STREET IMPROVEMENTS FOR OLD TOWN - PHASE 2 PART 1 - BOARDWALK

PROJECT NUMBER 472-82374

REVISED 11-30-93 SHEETS 1-5; ADDED SHEETS 6-7

11-30-93 REV. GENERAL NOTE #2 AND CONCRETE WALL NOTE #12

4 DECORATIVE STEEL RAILING ELEVATION - TYPICAL
0' 1' 2' 3' 1/2"=1'-0"

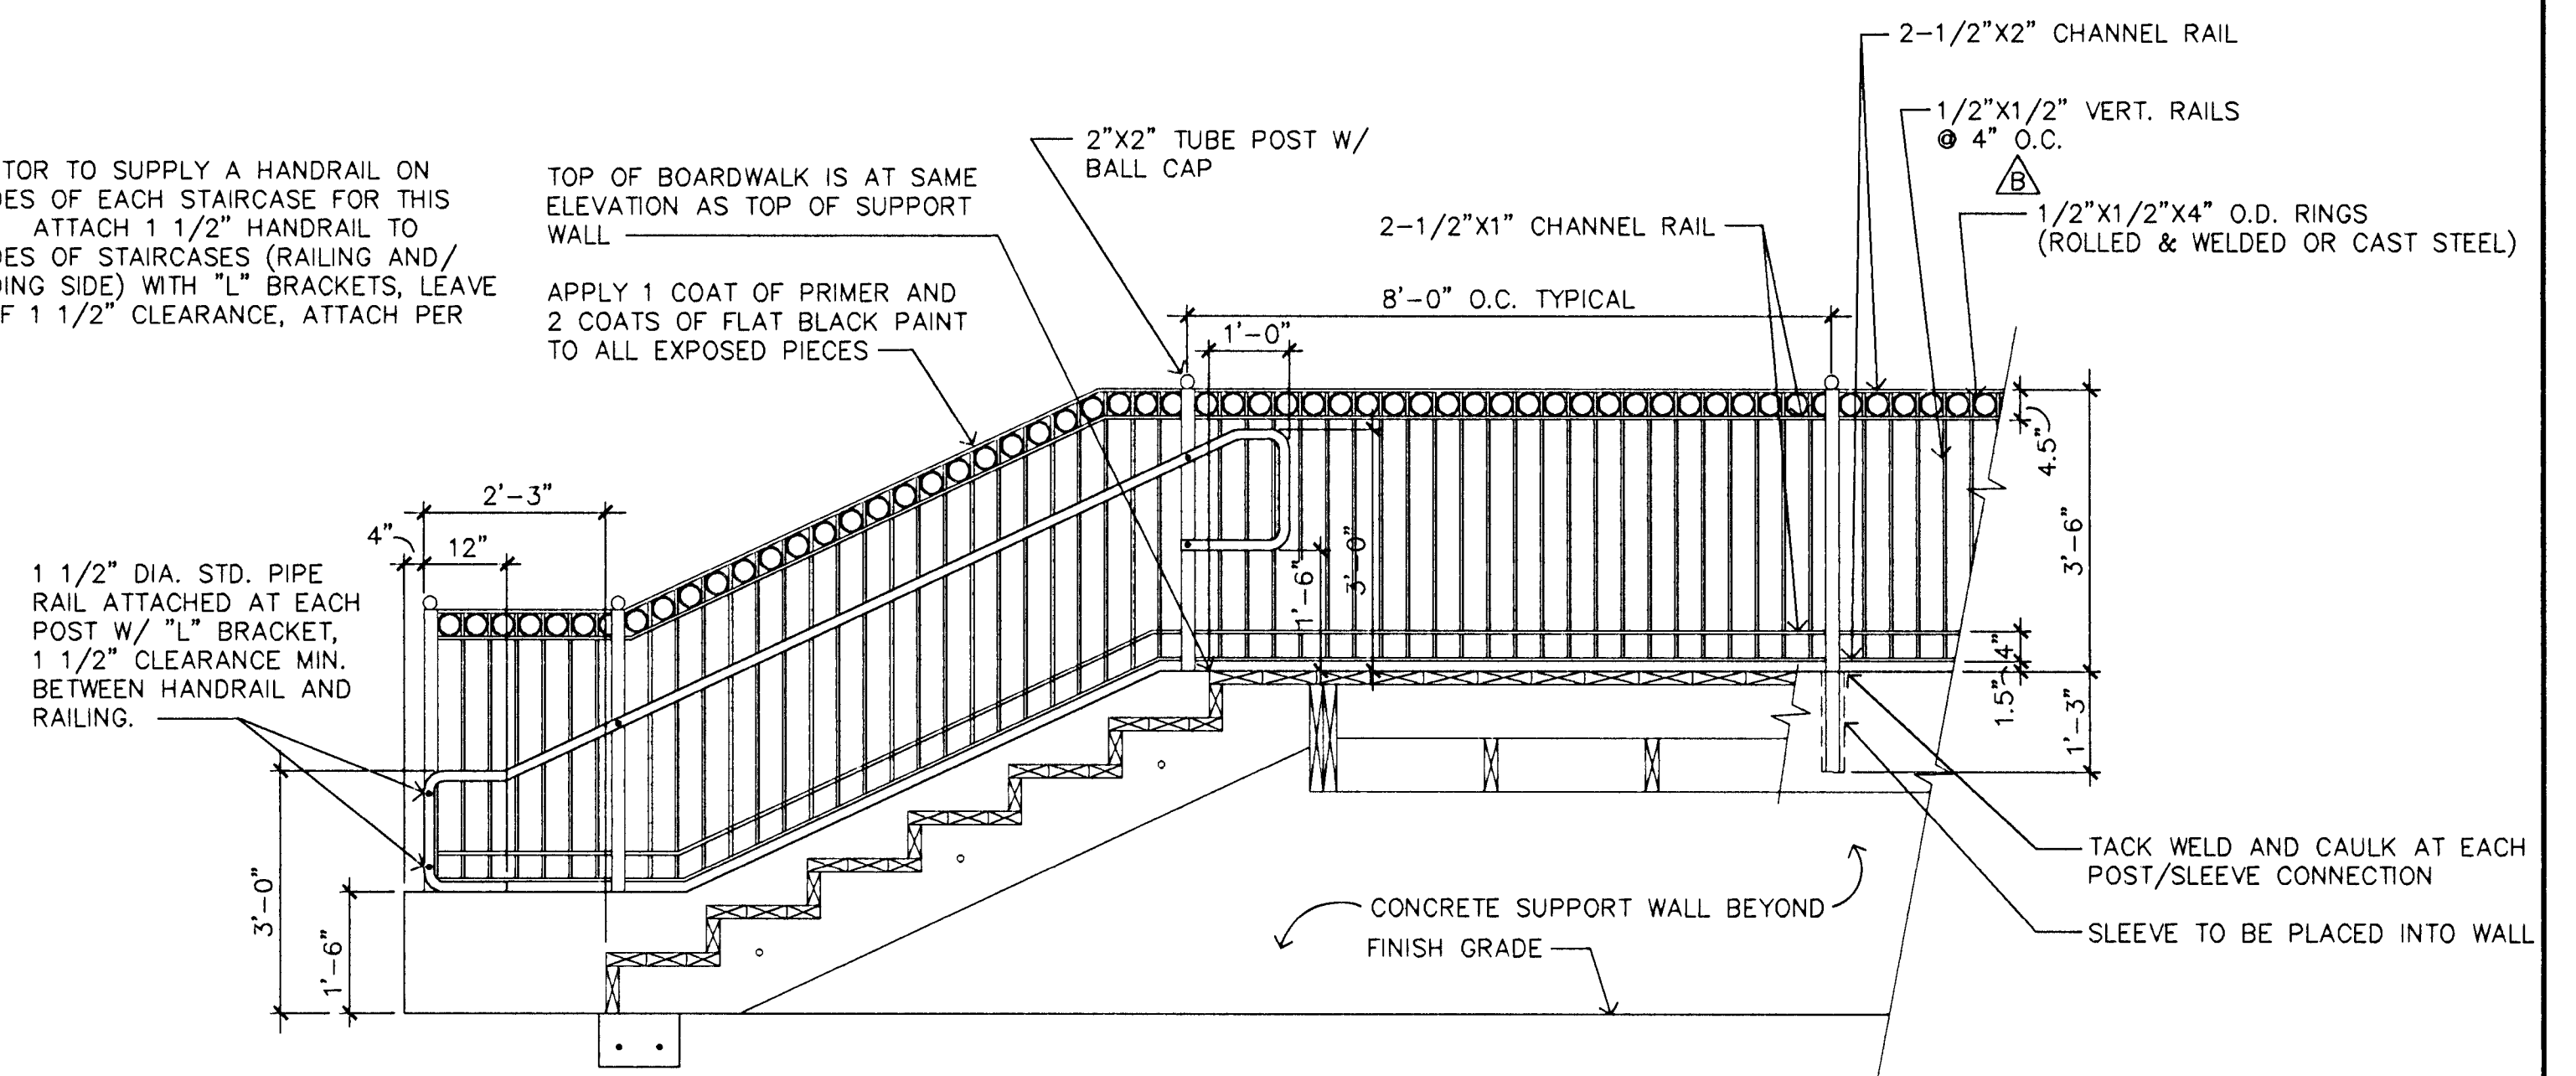
REVISED 1-31-94 DECORATIVE RINGS IN RAILING
REVISED 11-30-93 CHANNEL RAIL QUANTITY (DETAIL 4)

DECORATIVE STEEL RAILING ELEVATION - TYPICAL

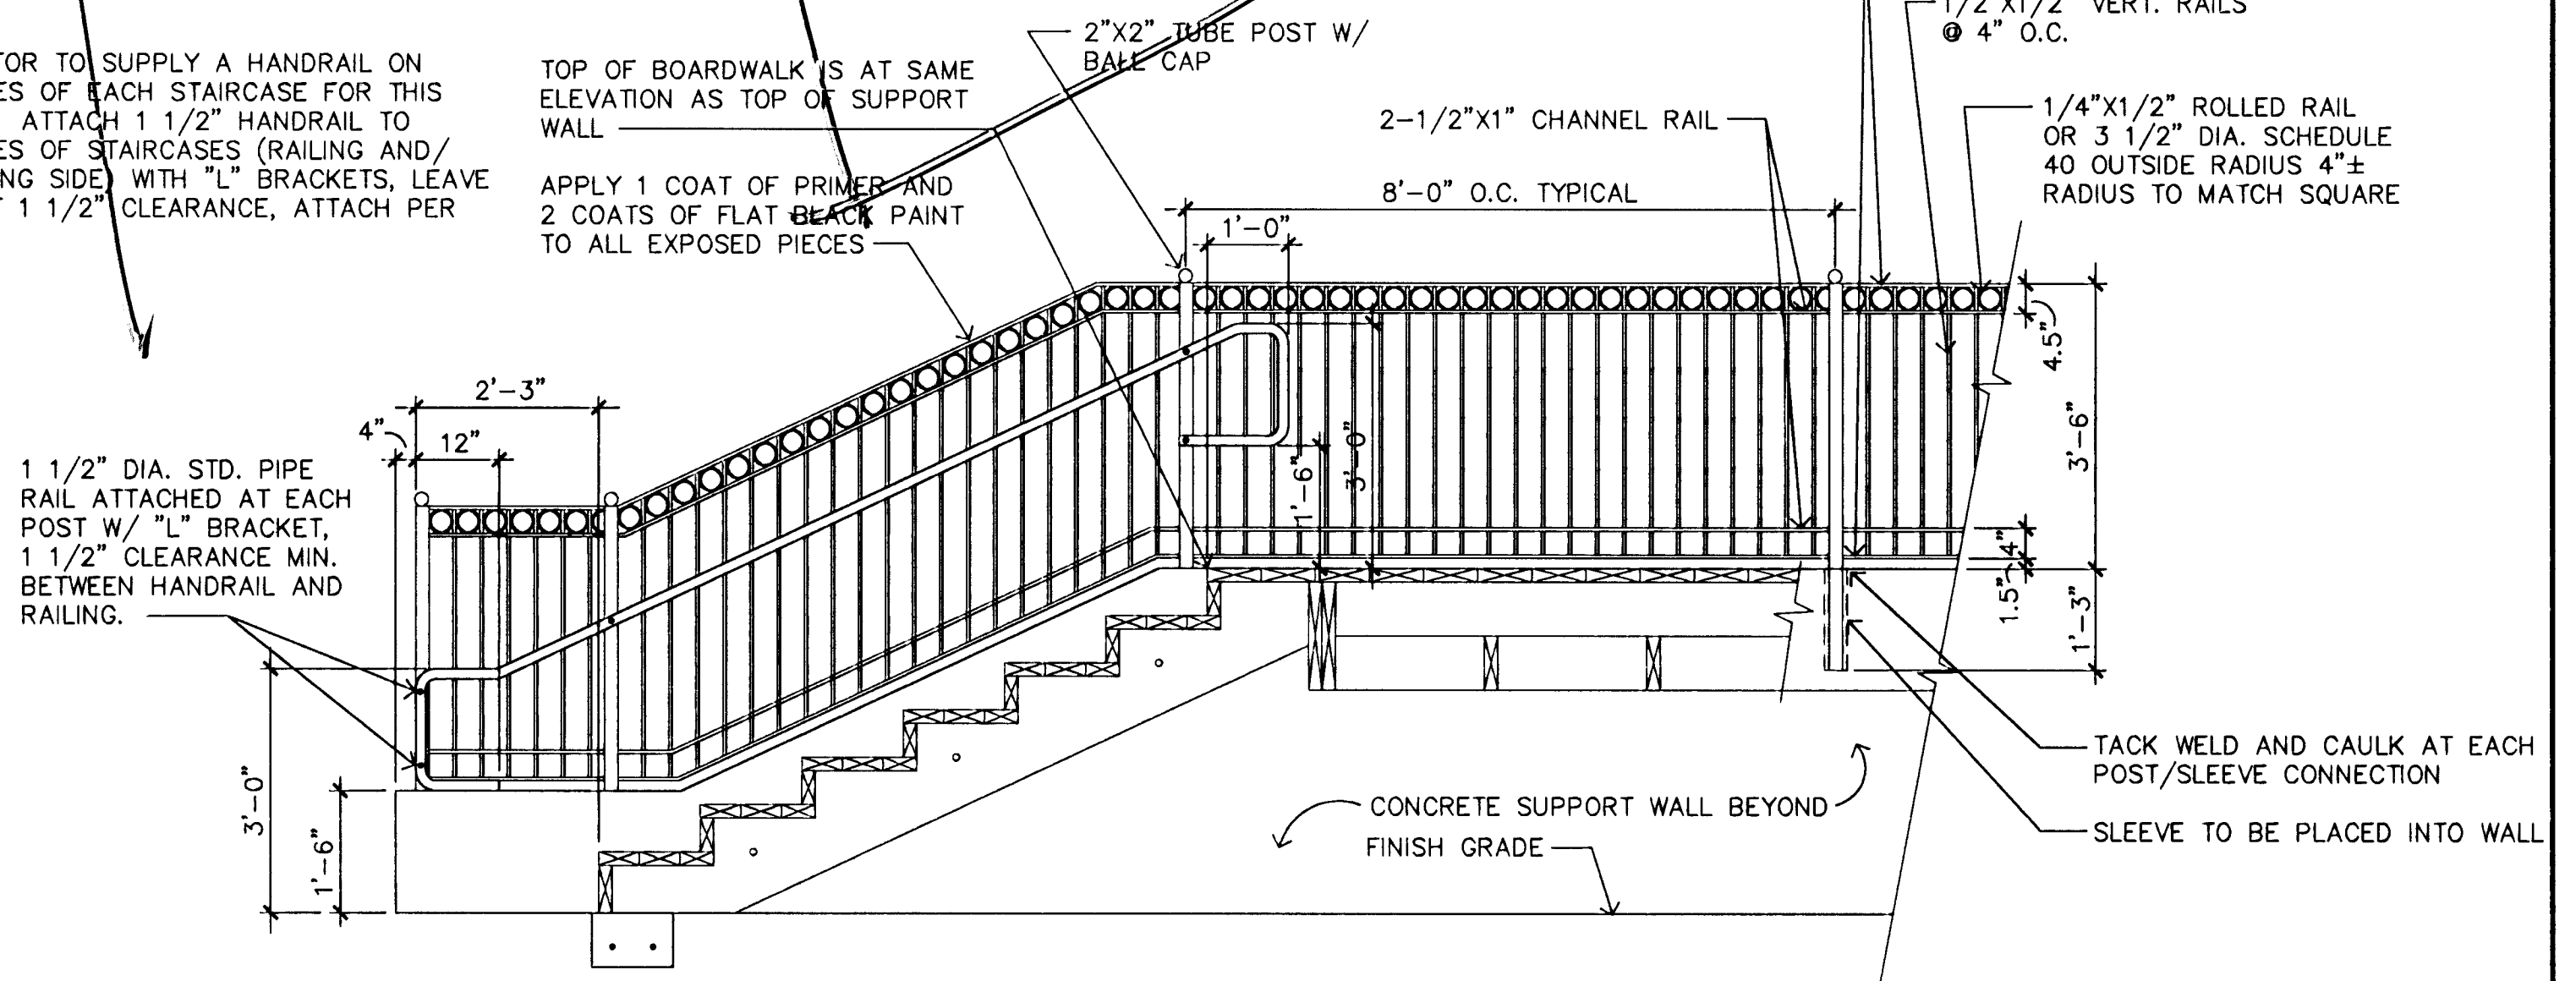
REVISED 11-30-93 CHANNEL RAIL QUANTITY (DETAIL 4)

1 BOARDWALK, RAMP AND PLANTER PLAN
 0' 4' 8' 12' 1/8"=1'-0"

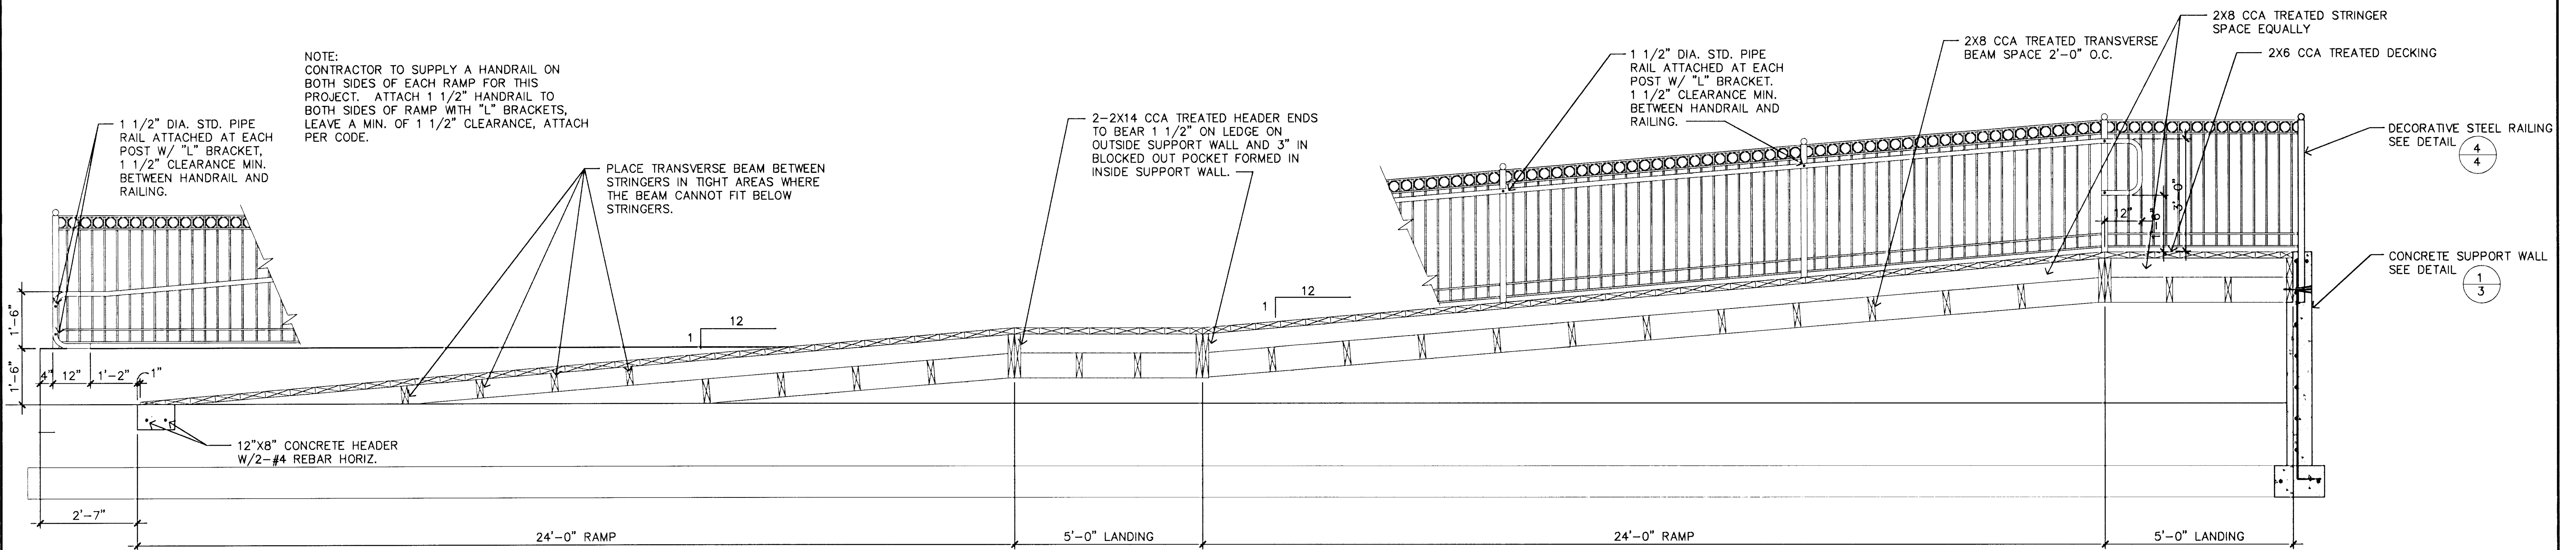
REV. 11-30-93 EXTENDED BOARDWALK & RELOCATED MANHOLE
